SIMPLIFIED SCHEMATIC DIAGRAM OF VALVE FB42 CONTROL CIRCUIT

TABLE 3.3.3-1

EMERGENCY CORE COOLING SYSTEM ACTUATION INSTRUMENTATION

SUSQUEHANNA - UNIT 2

FIGURE 1

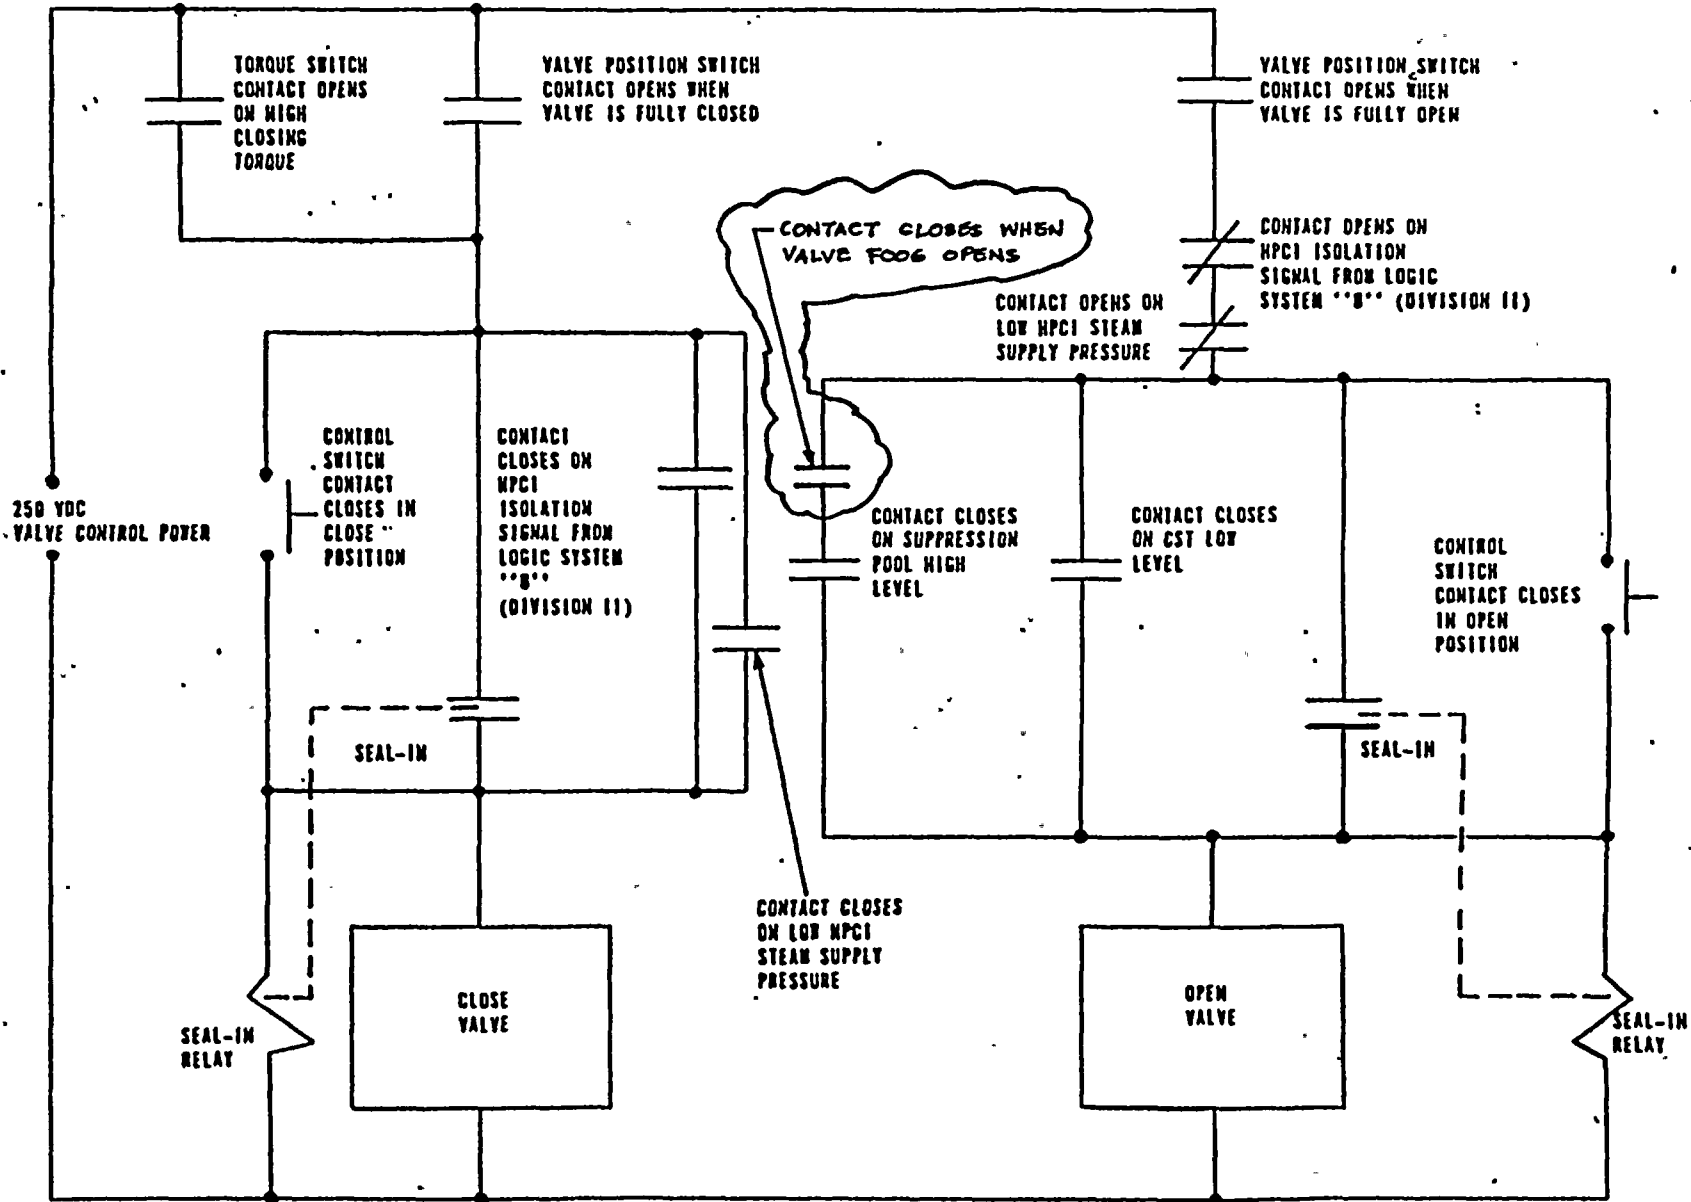
*** The automatic transfer of HPCI pump suction from the condensate storage tank to the suppression pool on high suppression pool water level occurs only when HPCI is required to inject into the vessel.

3. Performing a CHANNEL CALIBRATION of the CSS header ΔP instrumentation and verifying the setpoint to be ≤ 1 psid.
4. Verifying that the suction for the HPCI system is automatically transferred from the condensate storage tank to the suppression chamber ~~on a condensate storage tank water level low signal and on a suppression chamber - water level high signal~~ *either tank water level low signal and on a suppression chamber - water level high signal when HPCI is required to inject into the reactor vessel, or on a condensate storage tank water level low signal.*
